Safety Recalls

Codes: 1902 / 19N4

REVISION

Subject	After-Run Coolant Pump
Release Date	February 15, 2018
REVISION SUMMARY	<p>1902 – Updated claiming and work instructions to allow Pierburg pump installation on vehicles built after December 31 2012.</p> <p>19N4 – No changes.</p>
IMPORTANT! DO NOT PERFORM BOTH Safety Recall 1902 and Safety Recall 19N4	<p>All vehicles in Safety Recall 1902 are also in Safety Recall 19N4.</p> <p><u>Only one recall should be completed on each vehicle.</u></p> <ul style="list-style-type: none"> ➤ Perform Safety Recall 1902 only if a replacement after-run coolant pump is available. ➤ Perform Safety Recall 19N4 only if a replacement after-run coolant pump is <u>NOT</u> available. <p>Enter your recall claim as soon as possible. A SAGA claim for one of these recalls will automatically close the other. This automatic closure is normally completed within one week but may take up to two weeks.</p>
Affected Vehicles	<p>U.S.A.: Certain 2012-2017 MY Audi vehicles with a 2.0L TFSI gasoline engine</p> <p>CANADA: Certain 2013-2017 MY Audi vehicles with a 2.0L TFSI gasoline engine</p> <p><i>Check Campaigns/Actions screen in Elsa on the day of repair to verify that

After-run Coolant Pump Identifier

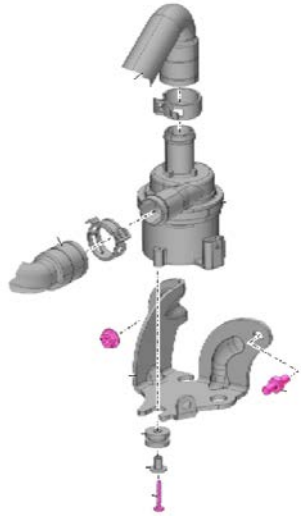
- Pierburg
- Buehler

Removing after-run coolant pump -V51-:

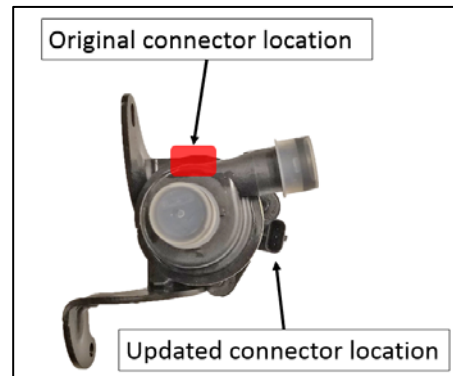
- The new after-run coolant pump comes with an updated bracket already installed. Bolts <1> will not require removal.

Installing new after-run coolant pump -V51-:

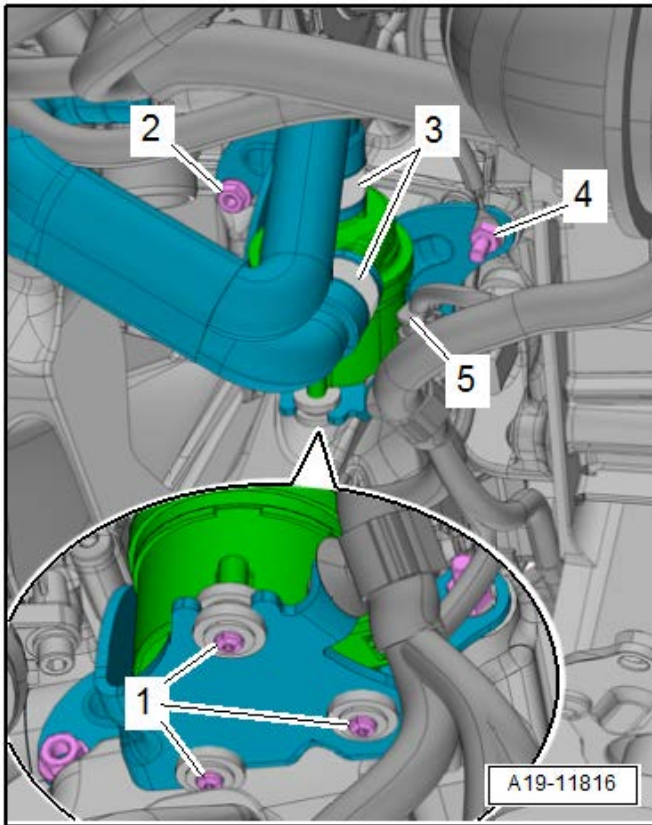
Due to the new location of the connector on the new pumps, the after-run coolant pump wiring harness <arrow> may have to be routed so it does not come into contact with the pump coolant hose.

- Install new after-run coolant pump/bracket assembly.

- Install nut <2> and torque to 9 Nm.
- Install double bolt at location <4> and torque to 9 Nm.
- Install ground wire.
- Install nut at location <4> and torque to 9 Nm.
- Install hoses and secure hose clamps <3>.
- Connect connector <5>.

Section C – 19N4 - Install Harness Plug

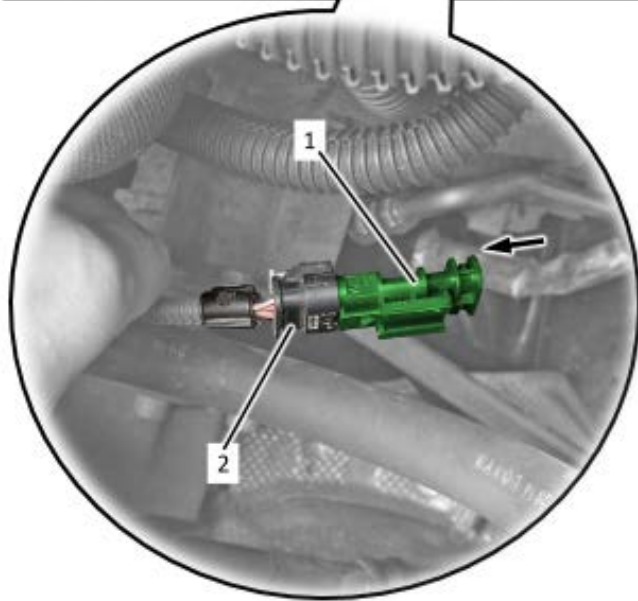
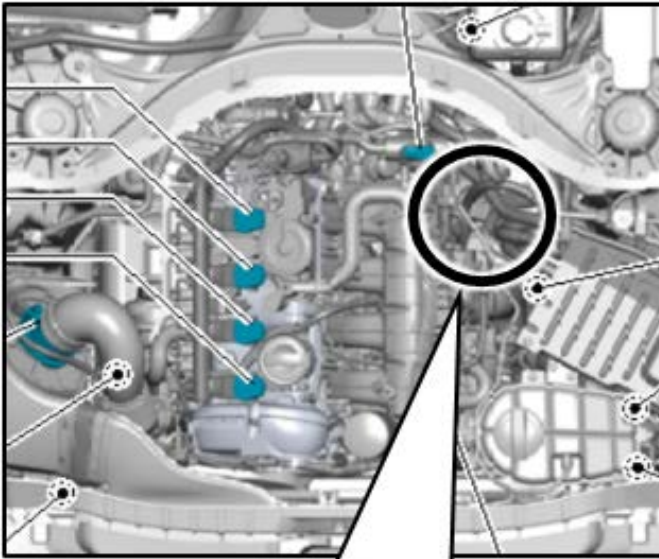
- Disconnect the connector <2> for the after-run coolant pump -V51-.
- Install connector plug <1> into connector <2> in direction of <arrow> and lock the locking tab on connector <2>.
